SUNDANCE WEST SUBDIVISION
EL PASO COUNTY, COLORADO
Grading & Erosion Control Plans

PCD FILE NO. SF-2527

GEC TITLE SHEET

GRADING AND EROSION CONTROL PLAN

SHEET: C1.0

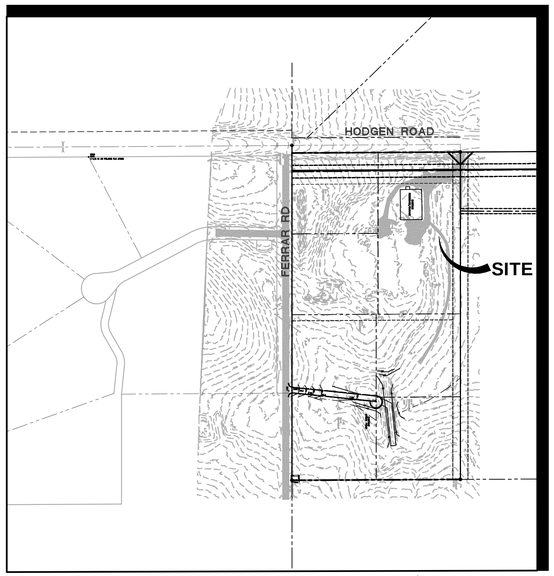
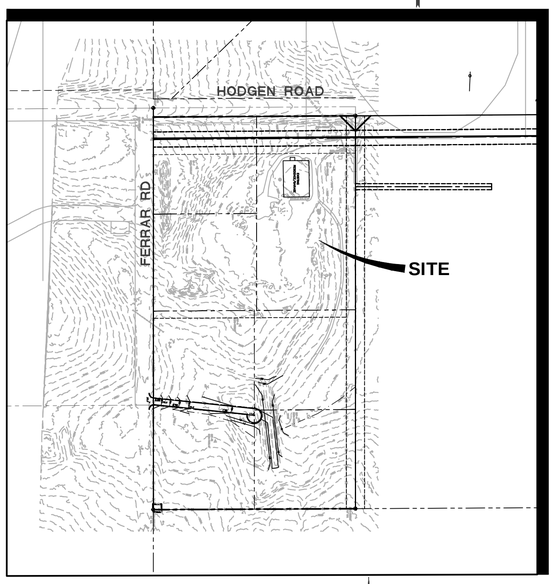
This is a copy of the GEC plan set. Please provide copy of CD's for improvements & access to Farrar Road

SHEET: C1.1

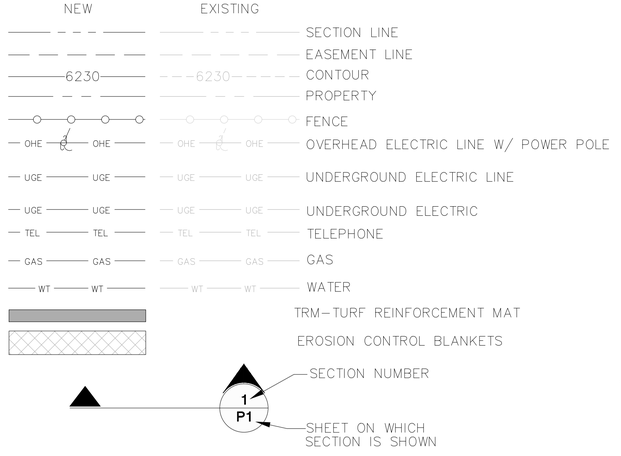
Access to Farrar Road will be removed as a part of this subdivision. Please depict and include any grading/stabilization needed to handle the flows coming through this area once the driveway is removed.

Include roadway surface hatch in the legend.

What is shown as the existing roadway is not accurate per the Traffic Impact Study that was submitted. Please revise existing roadway extents to be accurate.

Include CD sheets for the required improvements to Farrar Road to bring it up to County standards within the ROW. Criteria of Approval requires suitable access to minimum county standards and since the roadway does not meet minimum county standards it will need to be upgraded to minimum County standards. Construction Drawings and FAE will be required. An approved roadway termination/turnaround shall be constructed at the end of the County ROW. ECM 2.3.8.C.
